January 24, 2025 Project No. 31405228.001

RE: Shady Hills Energy Center, LLC
Shady Hills Combined Cycle Facility, Pasco County
Amendment to Certified Site Boundary and Stormwater Management Plan
Conditions of Certification PA 18-59

SHCCF Certified Site Boundary – Minor Change

SHCCF Stormwater Management Plan

PROJECT NO.	CONTROL	REV.	FIGURE
31405228.001	C009	0	3

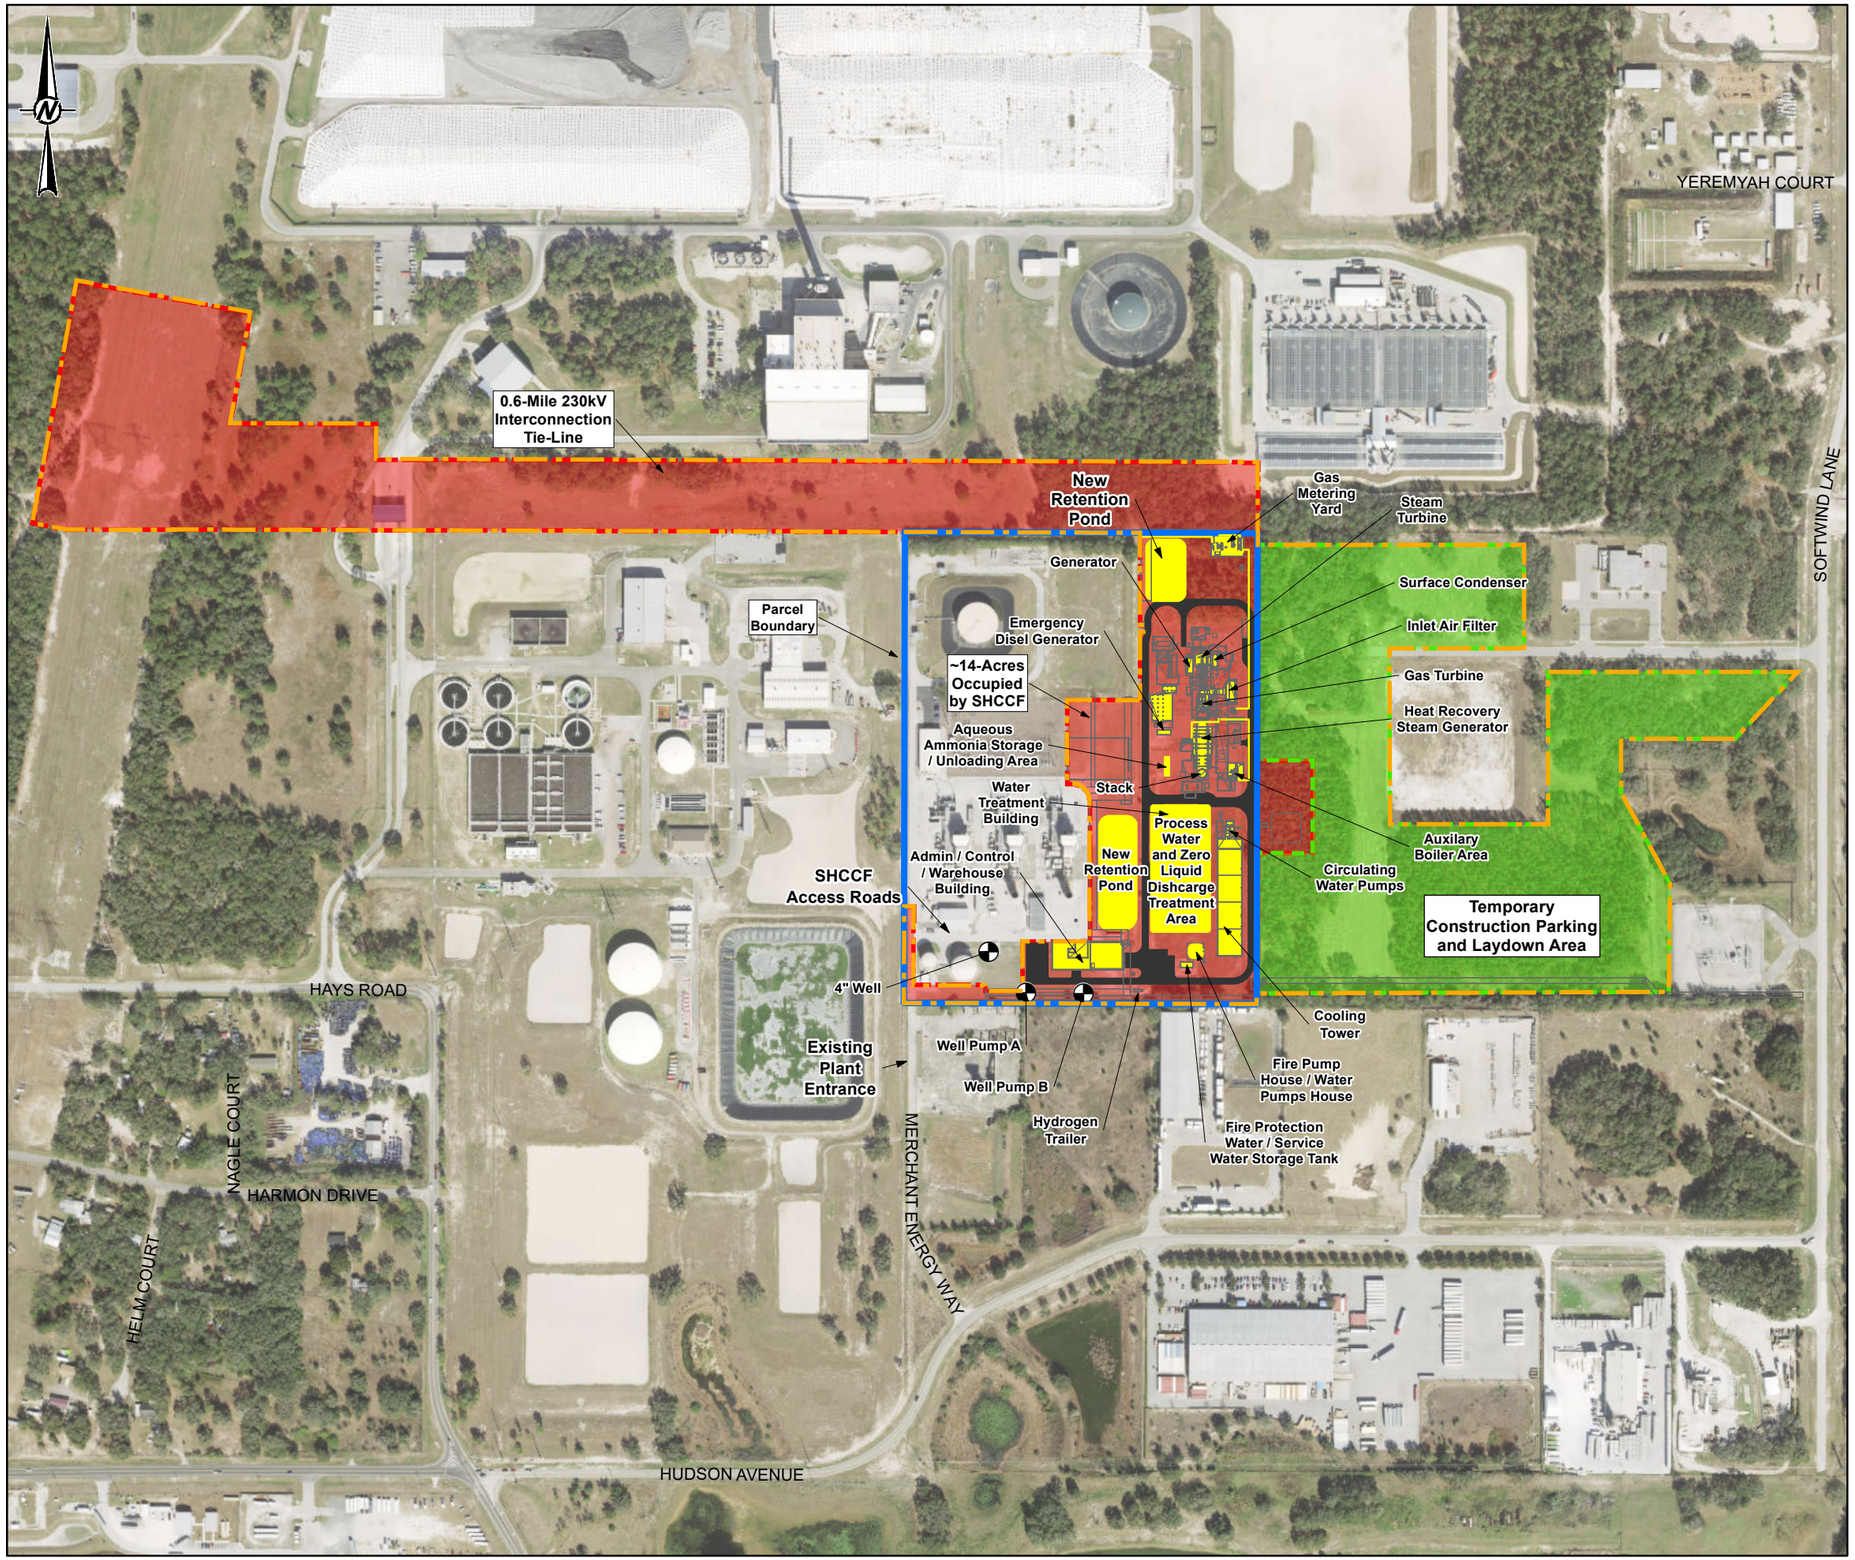
SHEC requests minor changes to the SHCCF Certified boundary as a result of the transfer of property between Seminole and SHEC. The minor changes to the SHCCF Certified boundary do not affect any of the SHCCF energy generation equipment or its ability to comply with the conditions of certification. The changes include the transfer of 0.92 acres from Seminole to SHEC. This area is being transferred to SHEC for the addition of the reclaimed water storage tank and pad, an oil storage shed and pad and water pumps associated with the reclaimed water tank and pad (Attachment 1 - Figures 2 and 3).

The total boundary change for SHCCF is a net addition of 0.92 acres (Attachment 1 - Figures 3 and 4). A copy of the warranty deed which documents the property transfer is provided in Attachment 1 – Figure 5.

TITLE
SHCCF EXPANSION PROJECT SITE PLAN

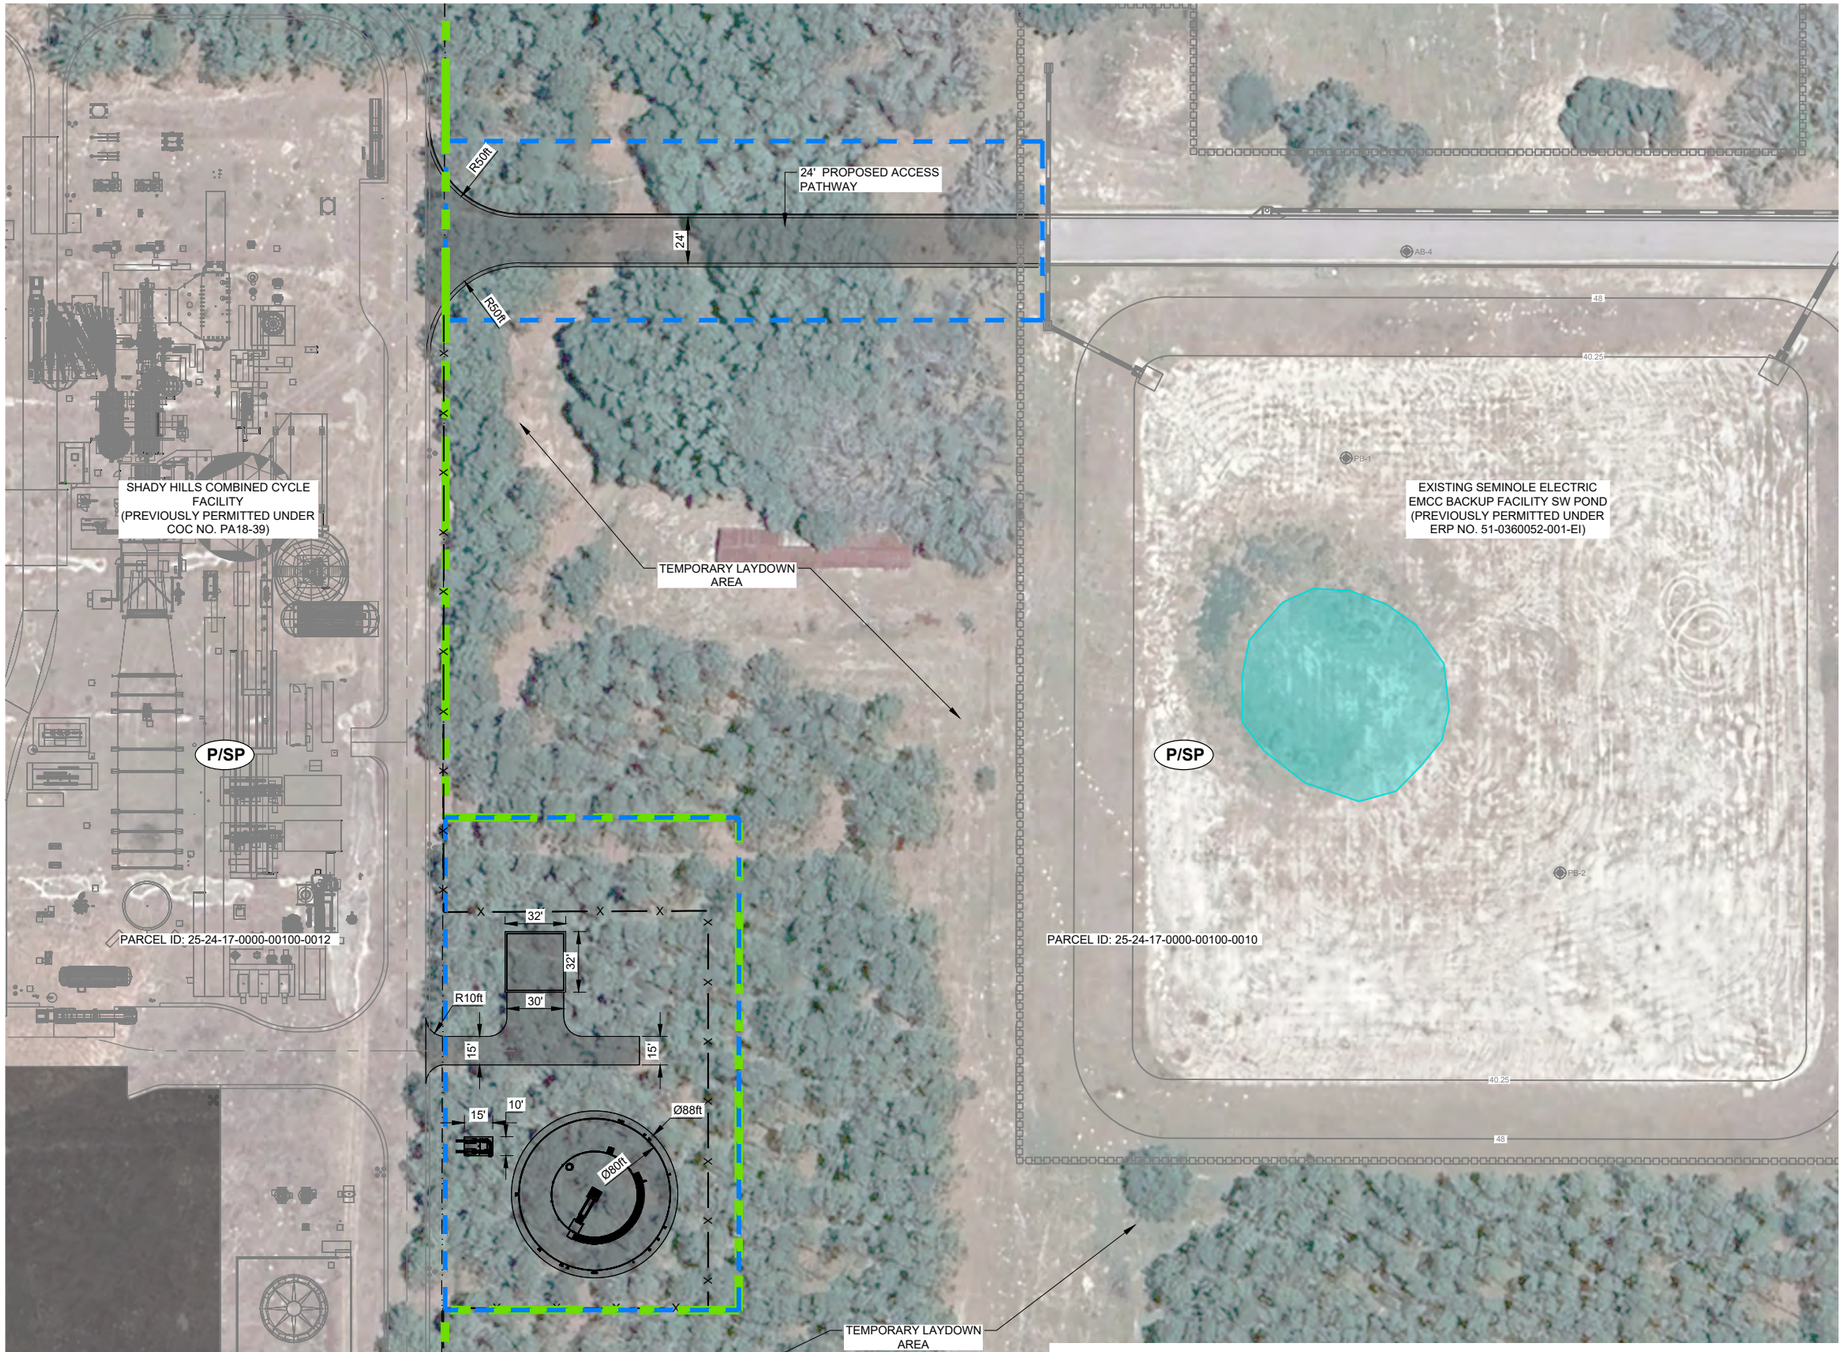
The SHEC Expansion Project includes the addition of a reclaimed water storage tank and pad, an oil storage shed and pad, water pumps associated with the reclaimed water tank and pad, and access pathways to provide ingress/egress to the proposed pads and equipment. An existing SW Pond located at the Seminole EMCC Facility will provide water quality treatment for runoff from the proposed access paths, reclaimed water tank pad, oil storage shed pad, and the pad associated with the reclaimed water tank pumps. Runoff will follow existing grade and sheet flow in the SW Pond.

TITLE
SITE PLAN

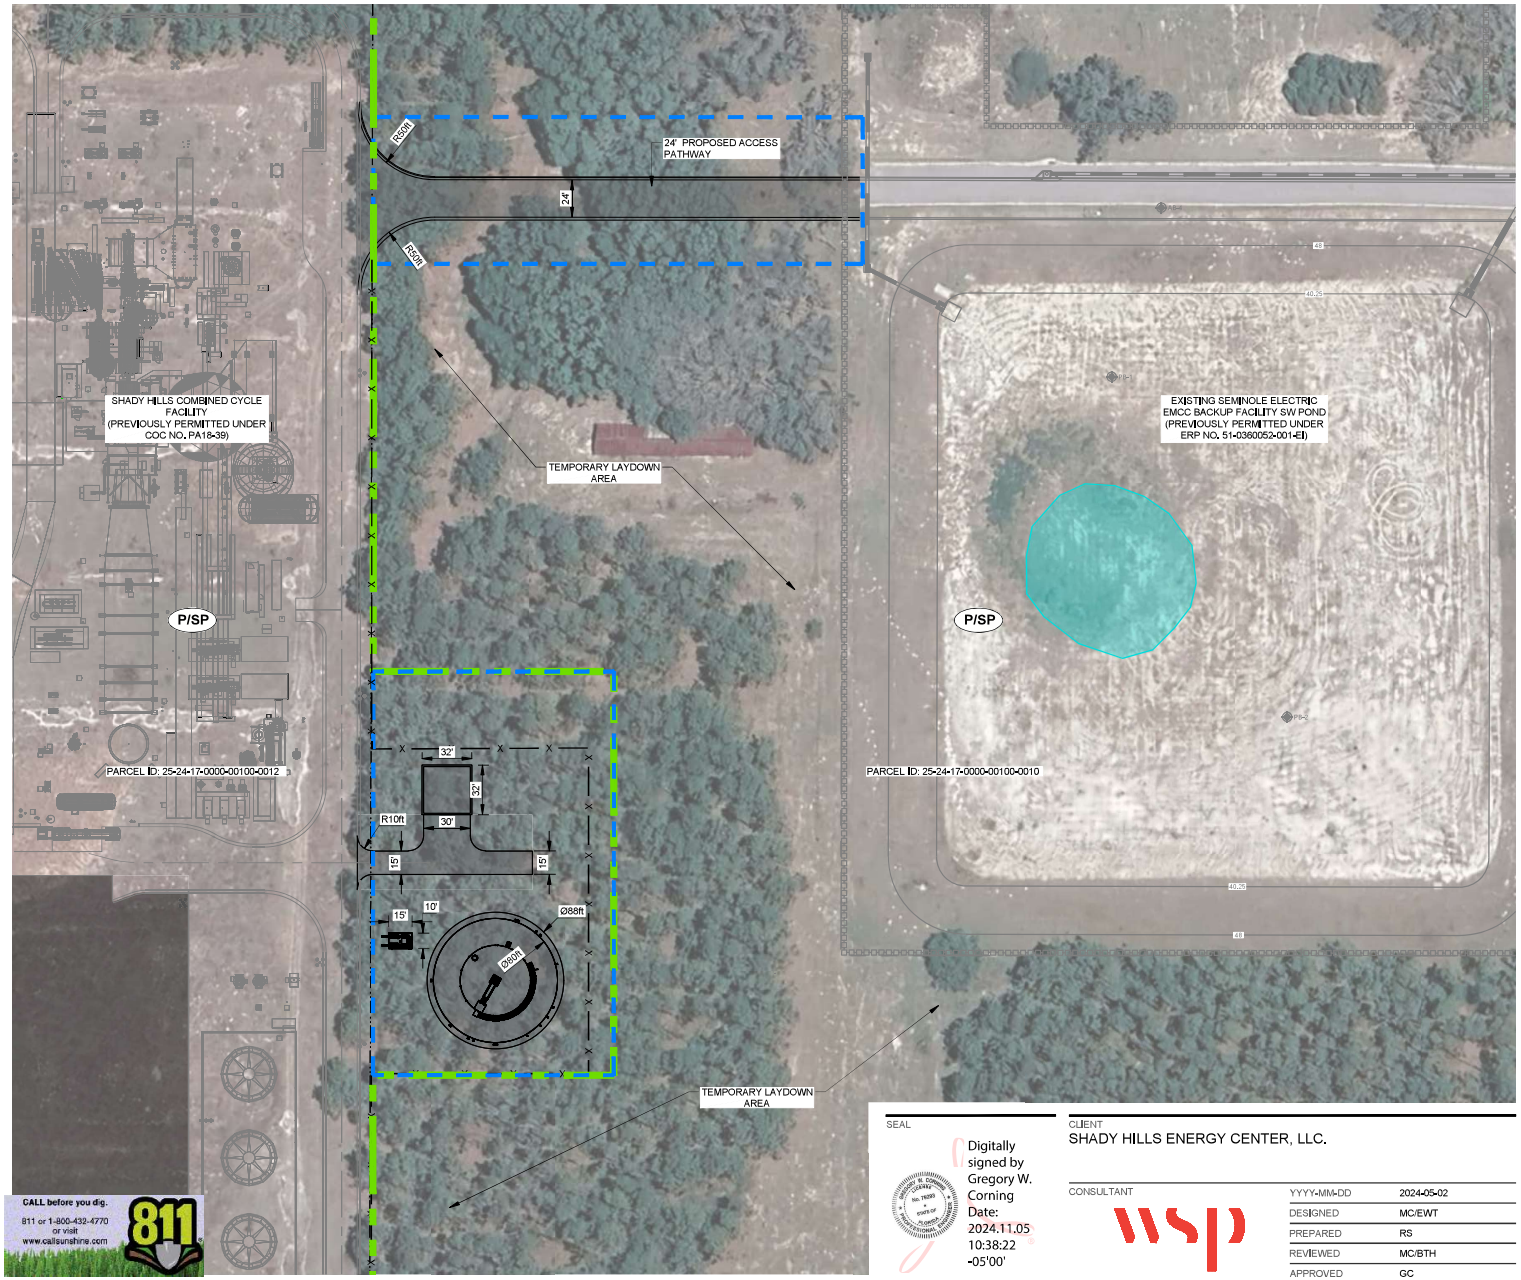
Your request to modify permit number 51-0360052-001 has been reviewed by Department staff. The modifications include extending the expiration date of the permit's construction phase from March 1, 2023, to February 1, 2027, adding a reclaimed water storage tank and pad with water pumps, an oil storage shed and pad, and an access pathway extension east of the Shady Hills Energy Center, with no proposed changes to the existing stormwater management system. The proposed activities are located within the landward extent of Buckhorn Creek, a Class III Florida Waterbody. The above changes are not expected to adversely affect water quality and will not be contrary to the public interest provided the following activity description and permit specific conditions are amended/added (~~strikethroughs~~ are deletions and underlines are additions) to the permit as issued:

Site development related to the proposed facility includes an approximate 10-acre project footprint with 2.26 acres of impervious area for the EOC office, pole barn, potable water meter, asphalt roadway, parking area, and concrete sidewalks. The reclaimed water storage tank and pad with water pumps, oil storage shed and pad, and access pathway add an additional 0.48 acres of

Since the proposed modification with the above permit conditions is not expected to result in any adverse environmental impact or water quality degradation, the permit is hereby modified as requested. By copy of this letter and the attached drawings, we are notifying all necessary parties of the modification(s).
